In Reply Refer To:
HSSD/SS-161

Thank you for your letter of November 30, 2009, requesting the Federal Highway Administration's (FHWA) acceptance of your company's School Zone Flashing Beacon system mounted to a schedule 40 galvanized steel pole on a Pelco 5300 series break-away base as a crashworthy system for use on the National Highway System (NHS). Accompanying your letter was a drawing of this system (enclosed for reference) and system specifications, typical of the largest and heaviest system you offer. You requested that we find the systems acceptable for use on the NHS under the provisions of the National Cooperative Highway Research Program (NCHRP) Report 350 "Recommended Procedures for the Safety Performance Evaluation of Highway Features."

Finished Look

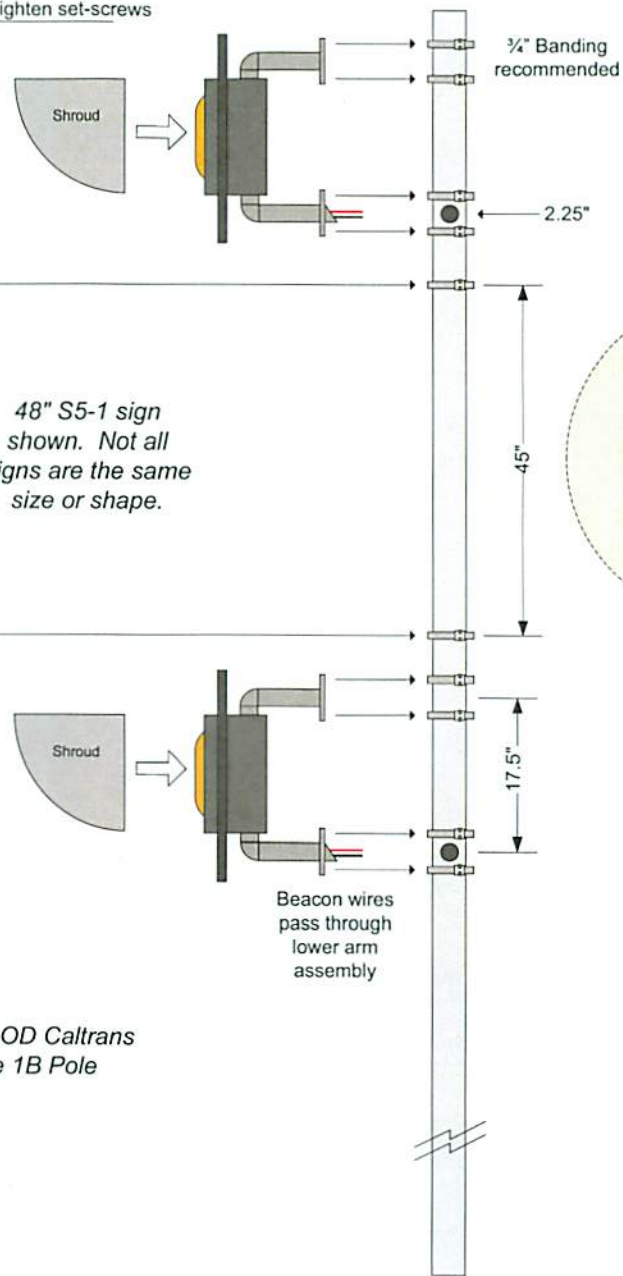
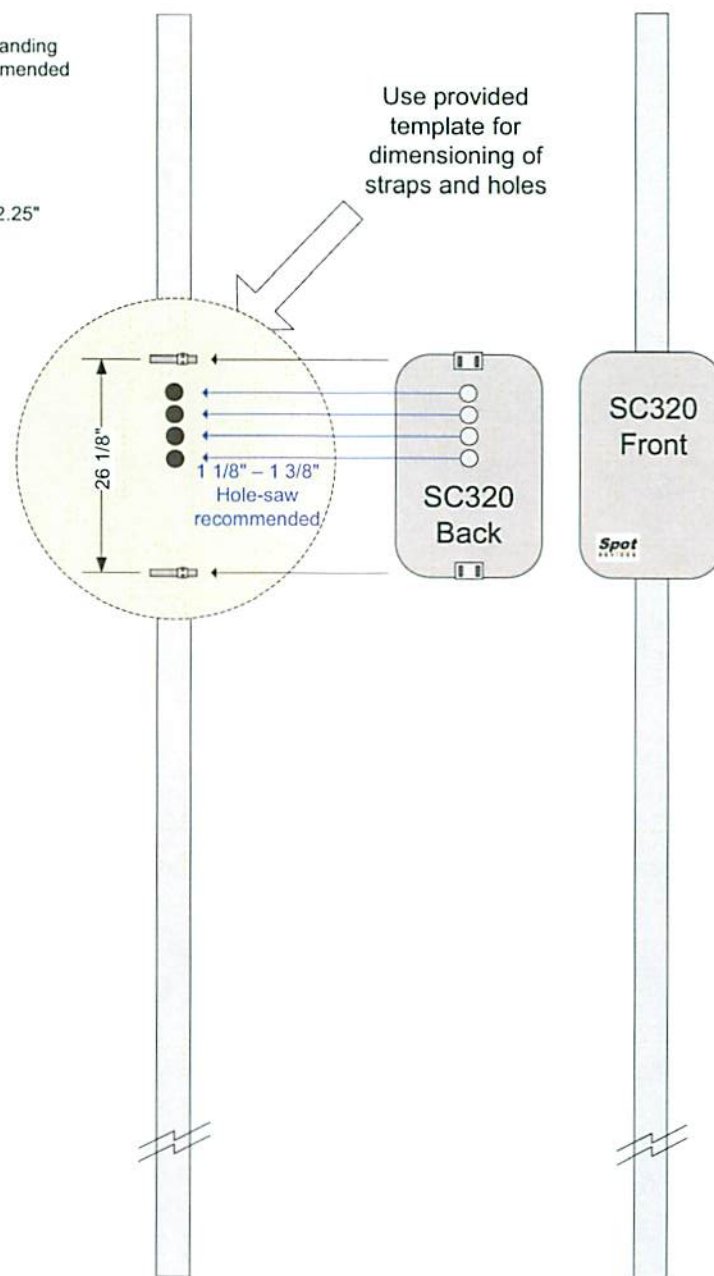
The enclosed diagram shows a common pole layout. You noted in some cases this setup will also have an additional side of pole solar panel mounted just below the top of pole solar panel, and this may take up an additional 24 inches of pole height, so the total pole height would be 17 feet. The Schedule 40 galvanized steel poles, threaded at one end, conform to ASTM A53 specifications. The diagram also shows the significant holes that would be drilled in the pole -- one 2.25-inch hole for each beacon, and four closely spaced 1.125-inch holes for the controller wiring. The height of the lowest hole will be no lower than 84 inches above the ground.

Therefore, the systems described in the requests above and detailed in the enclosed drawing are acceptable for use on the NHS under NCHRP Report 350 Test Level 3 conditions when such use is acceptable to a highway agency. This acceptance will be limited to use with Schedule 40 steel poles mounted on the Pelco cast aluminum bases you referenced (FHWA Acceptance Letter B-18 dated May 5, 1992) on generic four-bolt breakaway slip bases or on a comparable breakaway base using crashworthy frangible couplings.
